SUNDRY NOTICES AND REPORTS ON WELLS
Do not use this form for proposals to drill or to re-enter an abandoned well. Use form 3160-3 (APD) for such proposals.

5. Lease Serial No. SHL NM-99032 BHL NM-15007
6. If Indian, Allottee or Tribe Name
7. If Unit or CA/Agreement, Name and/or No. Pending
8. Well Name and No. Glenwood 28 Federal Com No. 2
9. API Well No. 30-015-36140
10. Field and Pool, or Exploratory Area Abo Wildcat
11. County or Parish, State Eddy County, NM

Cimarex wishes to change its casing program* for the well mentioned above as shown on the attached pages.

**Glenwood 28 Federal Com #2
Cimarex Energy Co. of Colorado
April 4, 2008
Casing Alteration
Conditions of Approval**

DRILLING PROGNOSIS Cimarex Energy Company

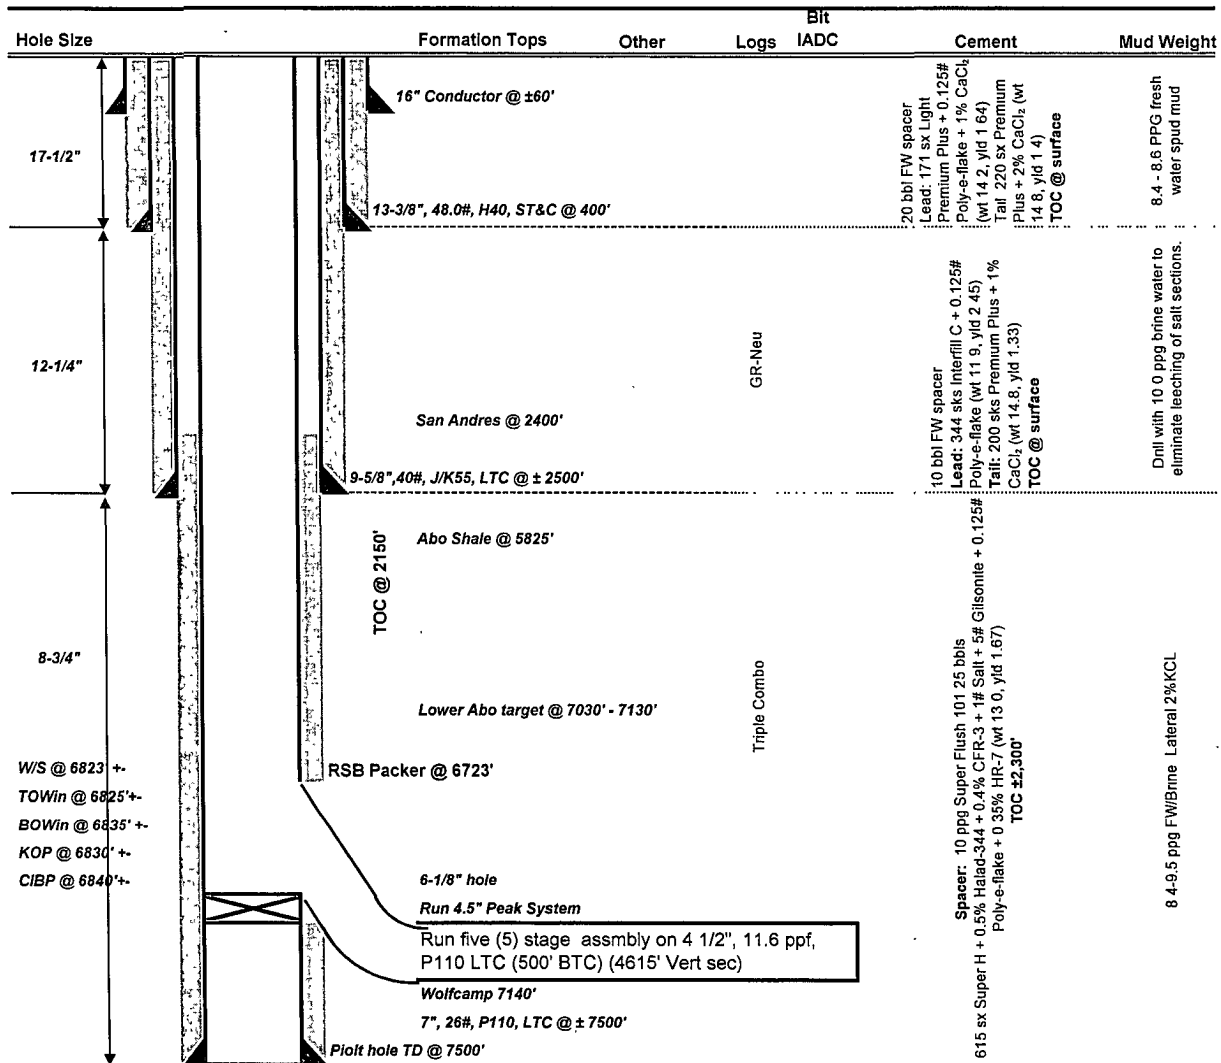
*50 hrs intermediate
9 1/2" casing lengths don't match,*

- 1. Plug at bottom of pilot hole from cementing of casing must be tagged and depth reported on subsequent report.**
- 2. Pilot hole will have to be plugged properly when the well is abandoned as well as horizontal leg with Iso-Pack liner.**
- 3. Additional cement may be required on 7" casing to achieve TOC of 2300'. One inch remedial will not be possible. TOC must be verified by operator and must be at 2300' or shallower.**
- 4. Seal on Peak Systems Iso-Pack liner is to be tested per Onshore Oil and Gas Order 2.III.B.1.b. Please call BLM for witness of seal test. Test required even if the packer section will be removed to verify that frac fluid will go into the Iso-Pack liner.**
- 5. Sundry required when CIBP is knocked to bottom to form sump area.**
